STAFF REPORT
COMMUNITY DEVELOPMENT DEPARTMENT

HEARING DATE: April 19, 2022

SUBJECT: H-2021-0081
Vanguard Village – MDA, RZ, PP, CUP

2. Landscape Plan (date: 2/13/2022)

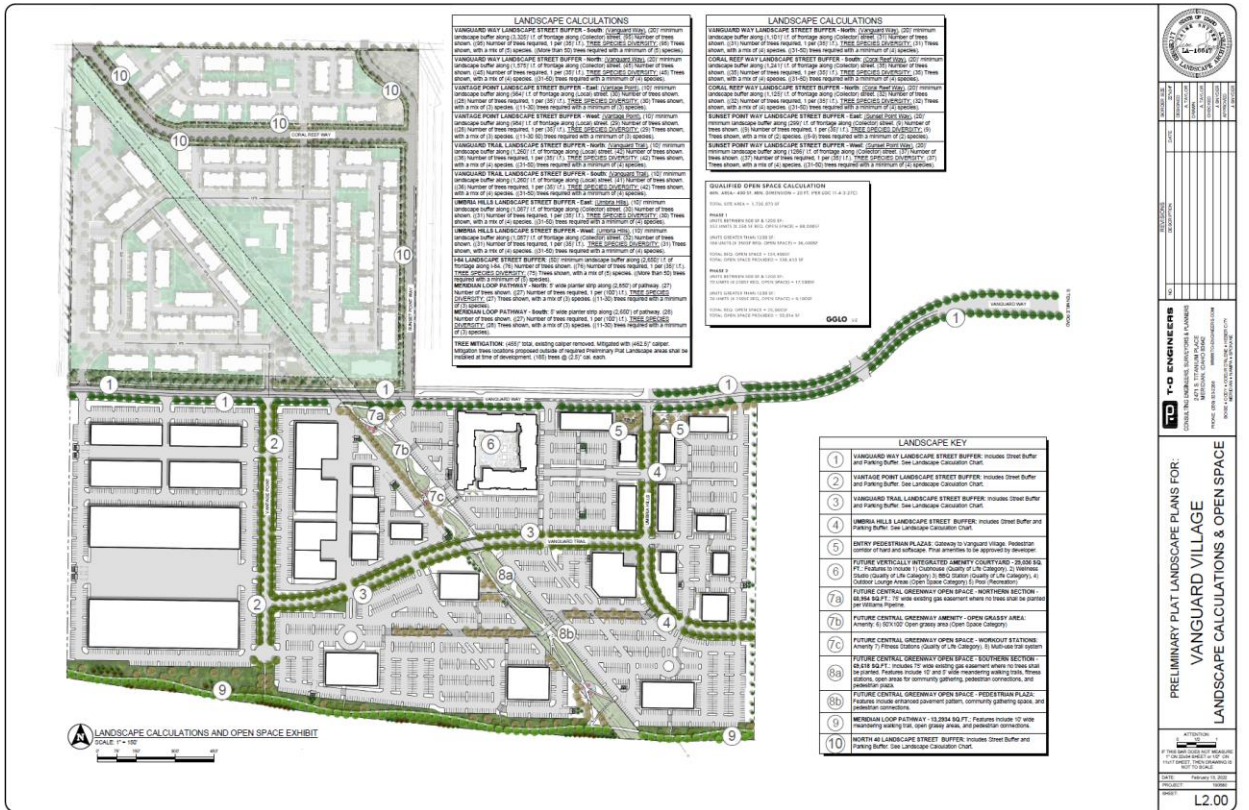
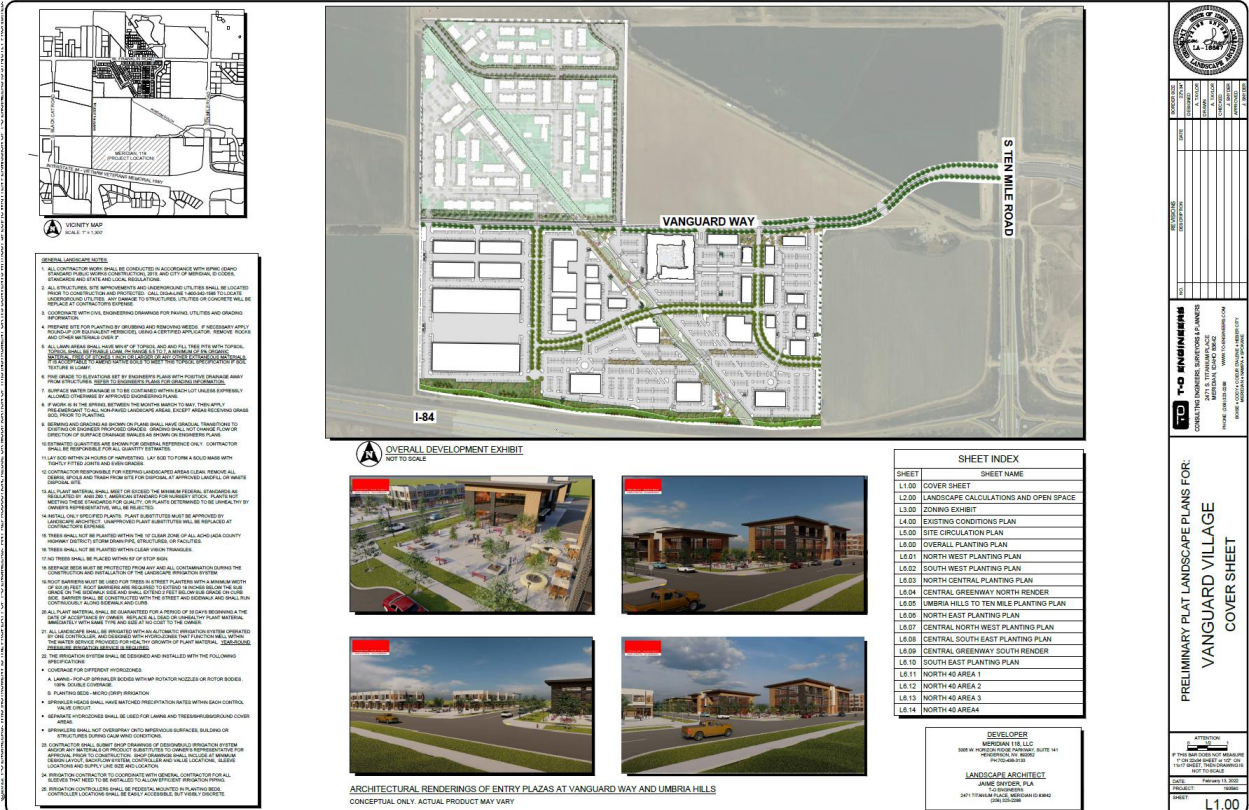
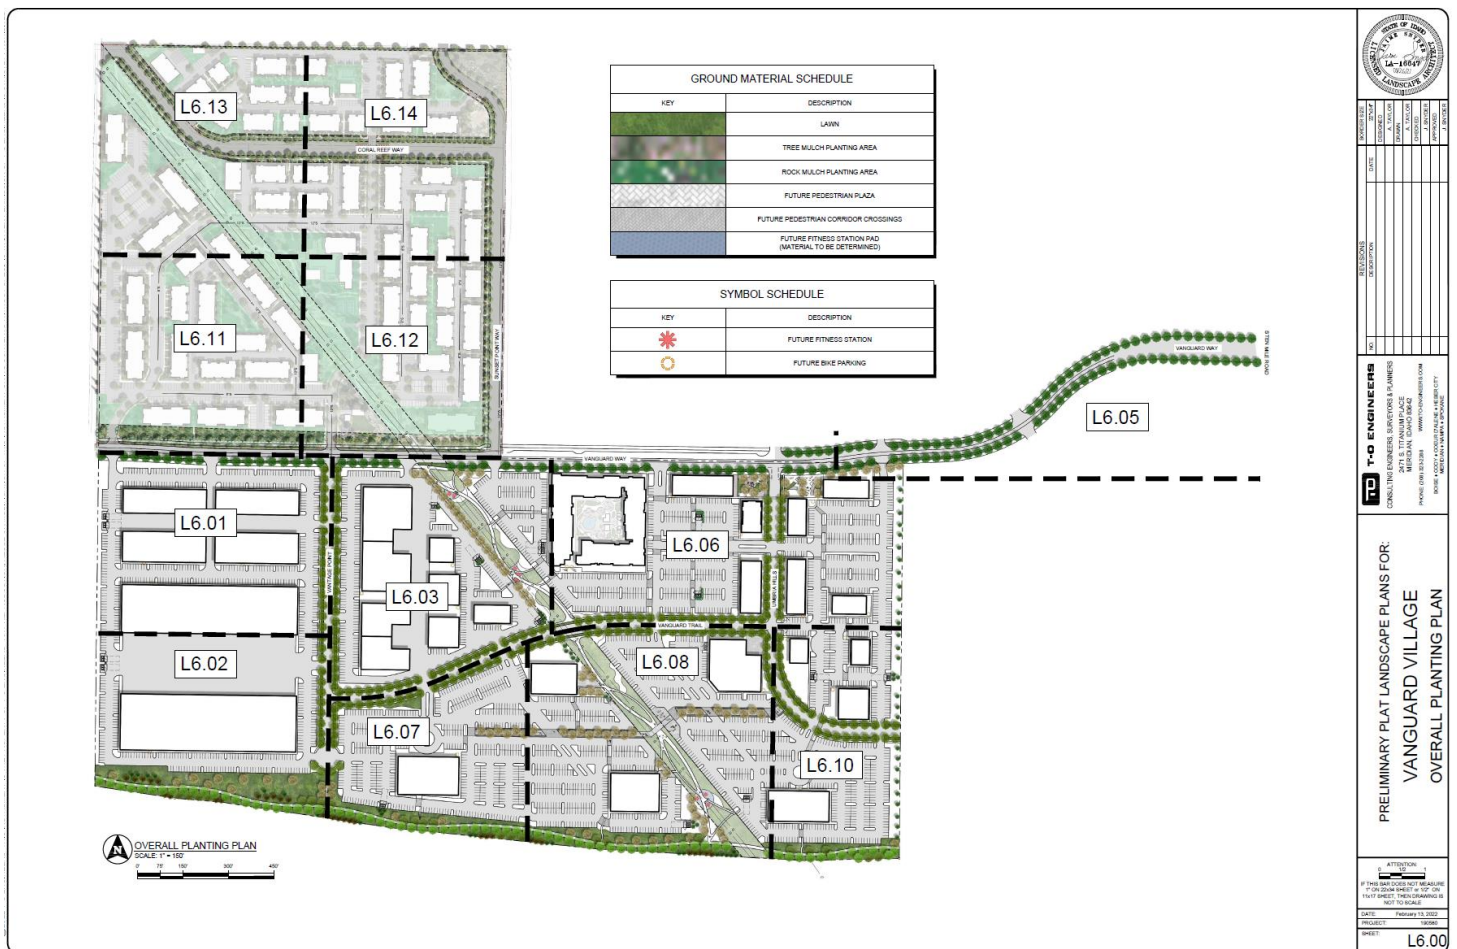
additional tree should be added within the street buffer along Umbria Hills (east) per the minimum standard.

Landscaping is required within parkways per the standards listed in UDC [11-3A-17](#) and [11-3B-7C](#). **Class II trees shall be provided in parkways in accord with UDC 11-3A-17E; Class III trees may be considered if the parkways are widened to 10 feet – revise the landscape plan accordingly.**

Landscaping is required along all pathways per the standards in UDC [11-3B-12C](#). A 5' wide landscape strip is required on both sides of the pathway planted with a *mix* of trees, shrubs, lawn and/or other vegetative ground cover. **If trees are not allowed within the pipeline easement, an additional 5-feet should be added to the common area outside of the easement to allow for trees; or, alternative compliance may be requested to the planting requirement.**

Mitigation is required for all existing trees 4" caliper or greater that are removed from the site in accord with the standards in UDC 11-3B-10C.5. Mitigation calculations are depicted on the landscape plan in accord with UDC standards (i.e. 185 trees at 2.5 caliper inches each for a total of 462.5 caliper inches). **The location of mitigation trees shall be depicted on a revised landscape plan submitted with the final plat application.**

- h. Mitigation trees shall be depicted on the plan (185 trees at 2.5 caliper inches each for a total of 462.5 caliper inches).
- i. If trees are not allowed within the pipeline easement, an additional 5-feet should be added to the common area outside of the easement to allow for trees; or, alternative compliance may be requested to the planting requirement for pathways and open space.

3. Circulation Plan - Revised

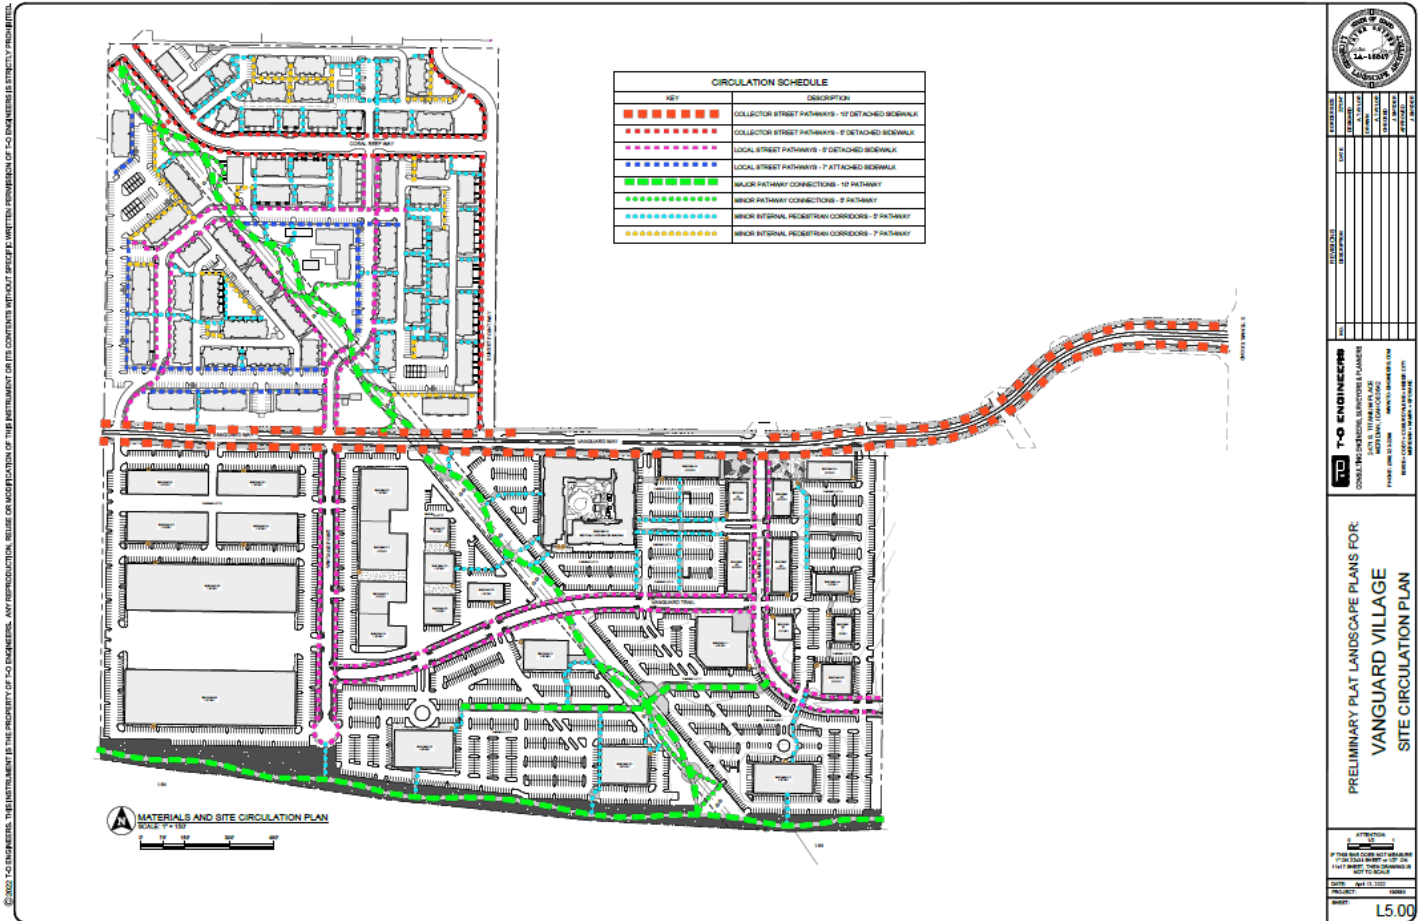
Pedestrian Circulation: A pedestrian circulation plan is included in Section VII.C.3 that depicts all sidewalks and pedestrian pathways planned throughout the site in accord with the TMISAP for mixed use areas.

1. Site Plan (dated: 10/6/21)

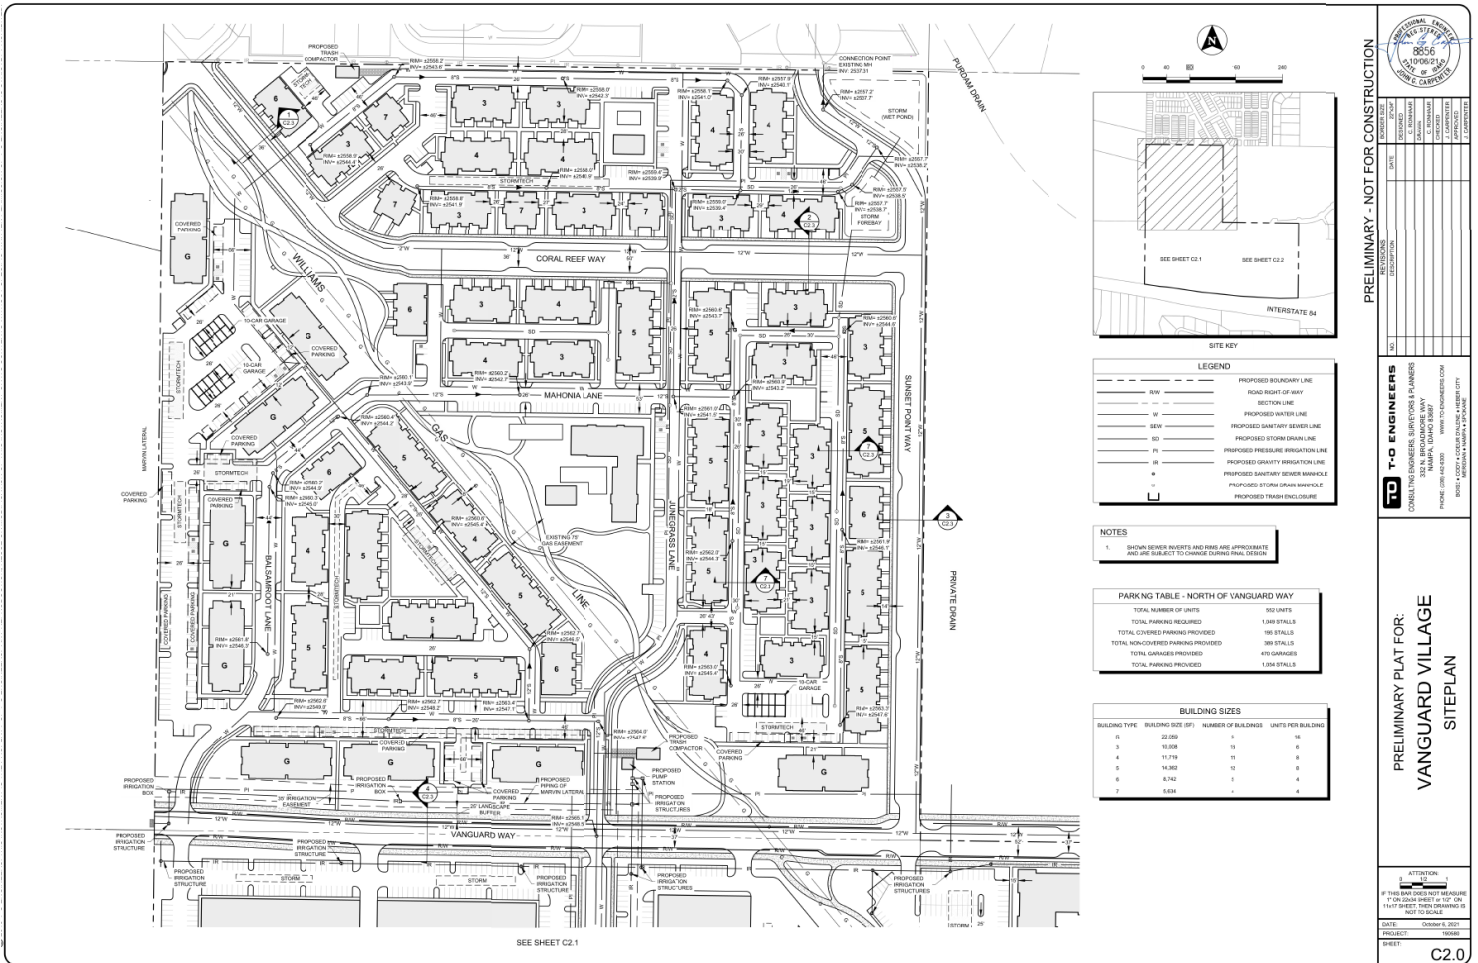
- c. Depict the location of the property management office, maintenance storage area, and central mailbox location (including provisions for parcel mail) on the site plan that provides safe pedestrian and/or vehicular access and the location of the directory & map of the development at an entrance or convenient location for those entering the development as set forth in UDC [11-4-3-27B.7](#).

- 3.2 Include a detail for the bicycle parking facilities that complies with the standards in UDC [11-3C-5C](#). Bicycle racks should be depicted in central locations for each building and for the clubhouse.

- 1.4. No permanent structures shall be within the footprint of a City utility easement including but not limited to buildings, carports, fences, infiltration trenches, trees, shrubs, light poles, etc. Based off the currently landscape plan, some trees will be in conflict with easements.

- 1.10. It is unclear by the provided plans how buildings will be served and how fire protection will be provided. An additional water loop around the buildings might be required to provide fire flow. A complete water plan will be required to be submitted and reviewed by Public Works Engineering before any final plat is approved.
